April 15, 2005

RE: Pace Canyon Fan Portal Amendment, Task #2104 - Dugout Canyon Mine, Canyon Fuel Company, LLC, C/007/039, Carbon County, Utah

**Title:** Pace Canyon Fan Portal - Task ID #2104, TA Response - Road Water Bars, Fan Evase, and Etc.

APPENDIX 5-10, FIGURE PC-1. TYPICAL CROSS-SECTION OF THE REALIGNED ROAD, PACE CANYON FAN FACILITIES

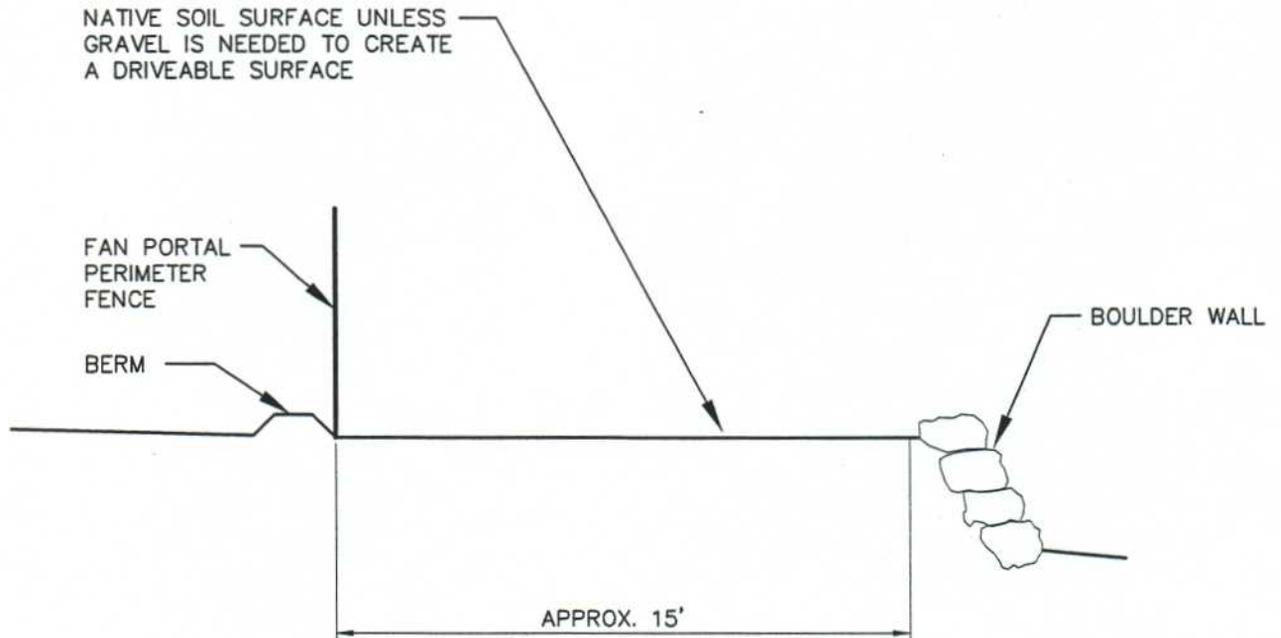
WATER BARS SHOULD BE INSTALLED WHERE SHOWN ON PLATE PC7-5.  
THE WATER BAR DESIGN CAN BE FOUND IN APPENDIX 7-12 ATTACHMENT 1.  
WATER BARS SHOULD DRAIN WATER OFF THE ROAD AT A 1 TO 3% SLOPE.
